## SERVICE BULLETIN

OIL - ENGINE- FANCASE - REPLACE IDG POWER CABLE SUPPORT BRACKETS - CATEGORY CODE 6 -  
MOD.ENG-79-0038

# V2500-ENG-79-0038

Installation of new IDG cable support brackets  
Fig.1 (Sheet 1)

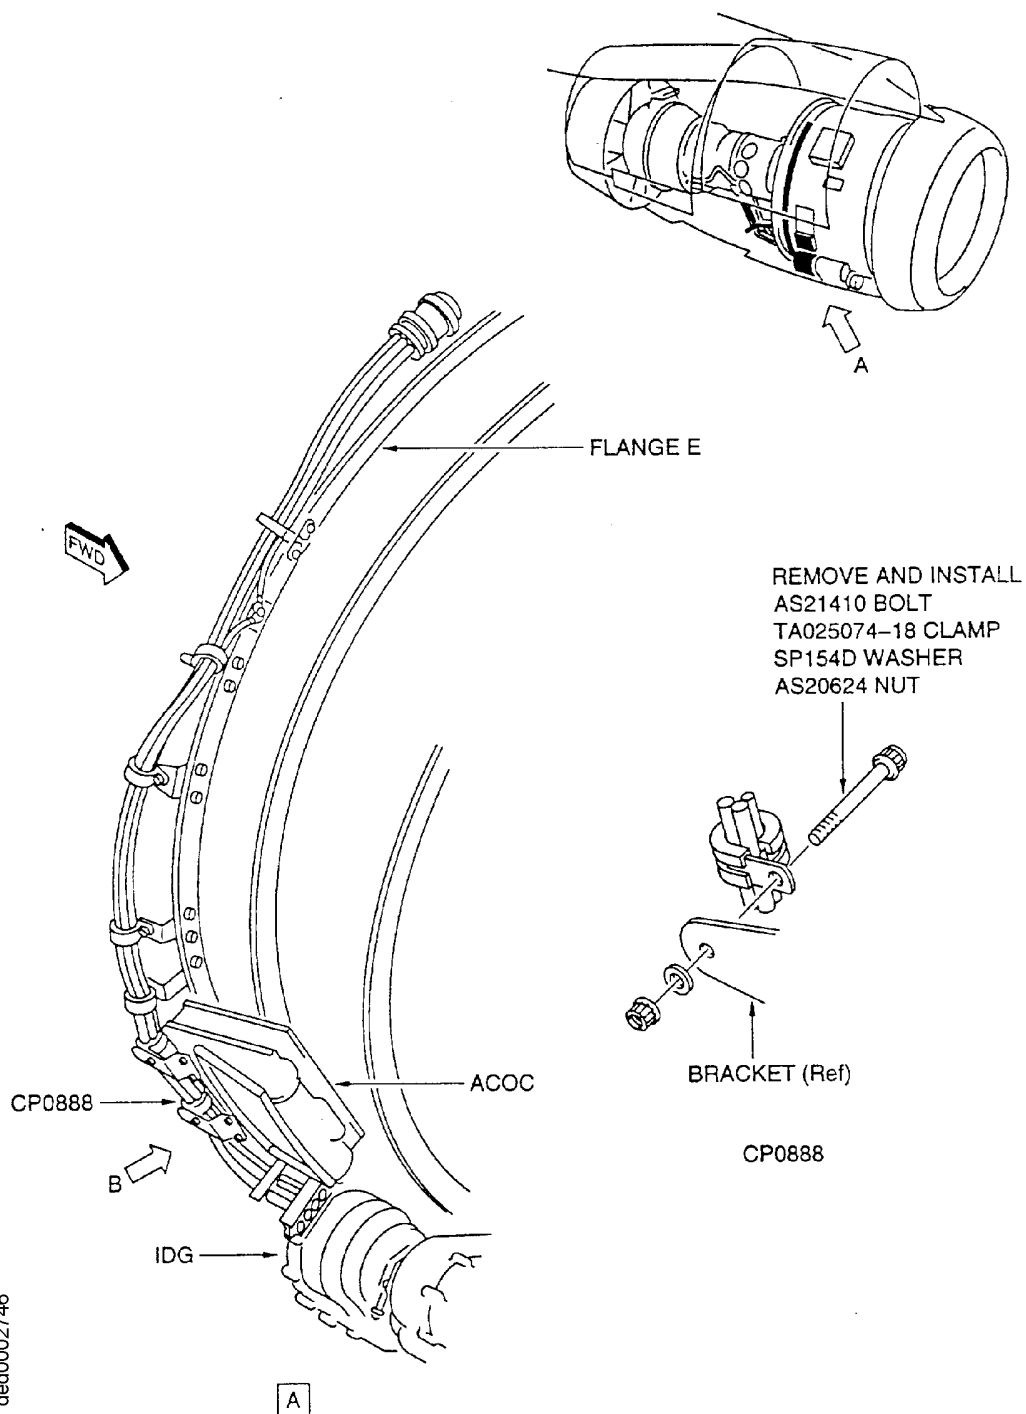
A new bracket and bracket support is introduced to replace the existing IDG power cable bracketry at Clipping point CP0888.

- (1) Install the new 745-5951-501 Bracket as shown with two 4W0169 Bolts and two MS9321-10 Washers. (Refer to Figures 1 and 2). Torque the bolts to 85 to 105 lbf in (10 to 12 Nm).
- (2) Install the new 745-5980-501 Bracket as shown with a 4W0169 Bolt, MS9321-10 Washer, 4W0002 Nut, AS21408 Bolt and an AS20624 Nut. Torque the bolts to 36 to 45 lbf in (4 to 5 Nm).
- (3) Assemble clipping point CP0888 as shown with a AS20624 Nut, AS21410 Bolt, SP154D Washer and TA025074-18 clamp. Torque the nut to 20 to 25 lbf in (2 to 3 Nm).
